**AL HADI PERMANENT POLICE
STATION
BASRAH, IRAQ**

**SIGIR PA-09-190
APRIL 21, 2010**

SUBJECT: Report on the Al Hadi Permanent Police Station, Basrah, Iraq
(SIGIR Report Number PA-09-190)

Figure 4. Contractor's site design (Courtesy of GRS)

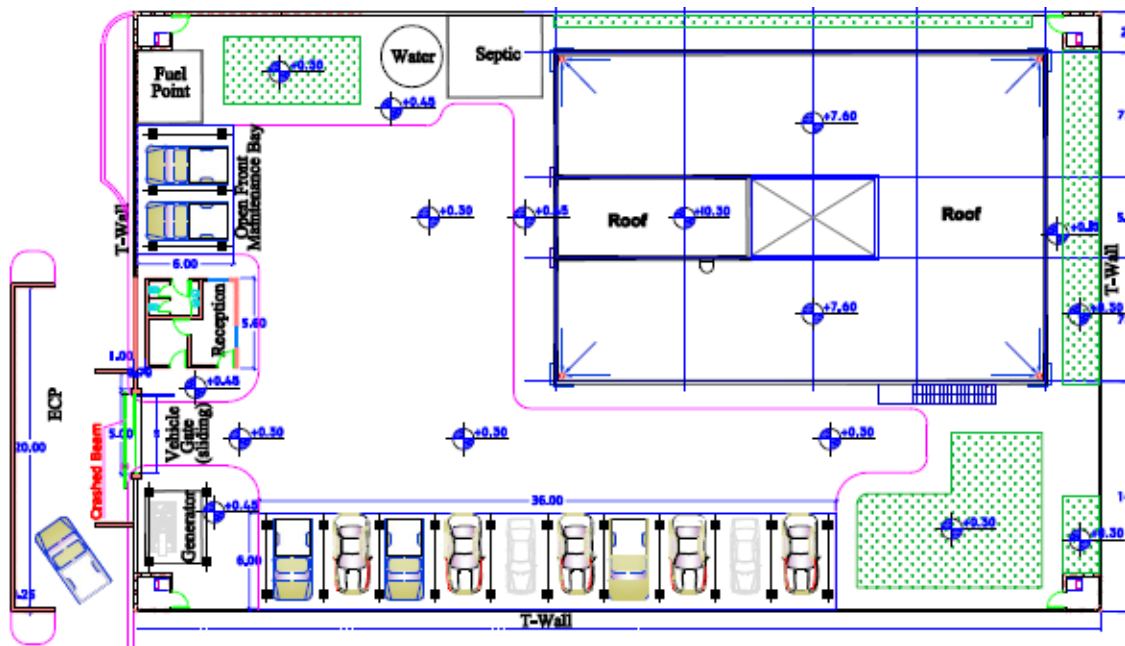
The contractor submitted an actual site plan for the project (Figure 4). The contractor's site plan included all of the items stated in the SOW and accommodated the actual conditions of the project site.

Figure 5. Non-acceptable and acceptable seismic reinforcing details (Courtesy of GRS)

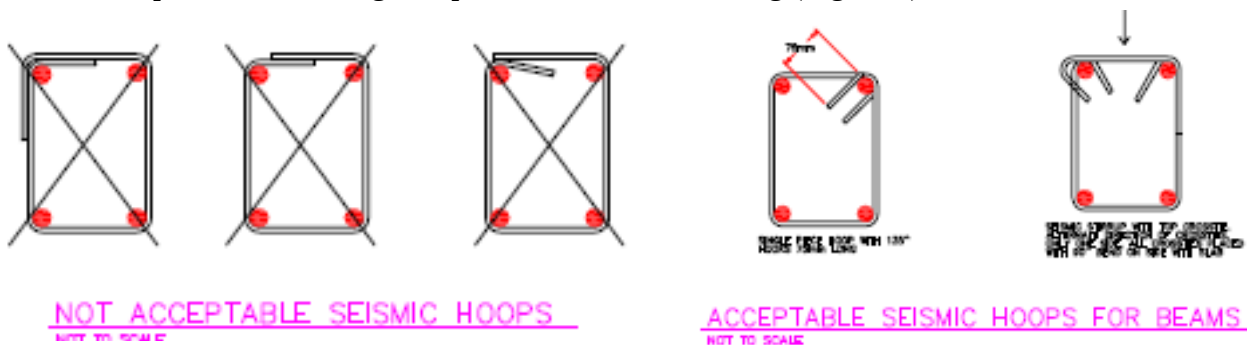
The design drawings included details for the reinforced concrete beams and columns. These details include the typical beam cross section, required primary moment⁷ reinforcing, and the shear reinforcing for the reinforced concrete beams. Details are also provided detailing acceptable seismic reinforcing (Figure 5).

Site Photo 10. Expansion joint between infill and frame

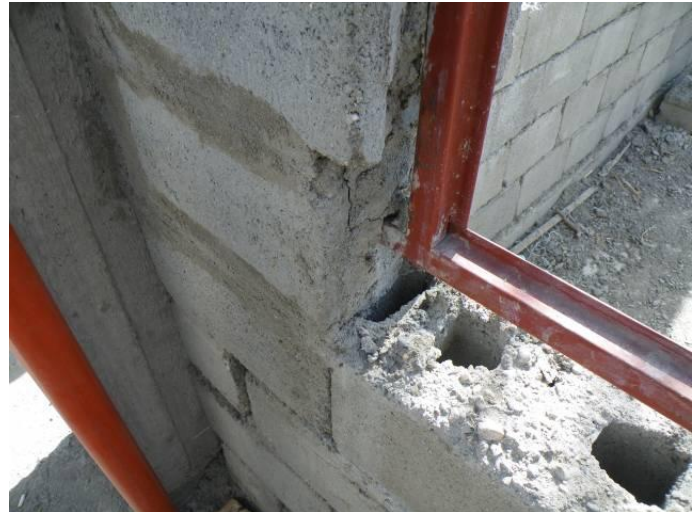
The contractor installed expansion joints between the reinforced concrete frame and the concrete masonry infill. The expansion joints consisted of approximately three centimeters (cm) of polystyrene (plastic) foam placed against the reinforced concrete column (Site Photo 10). This joint will effectively isolate the concrete masonry unit (CMU)⁹ from the reinforced concrete frame and allow for differential movement between the two elements.
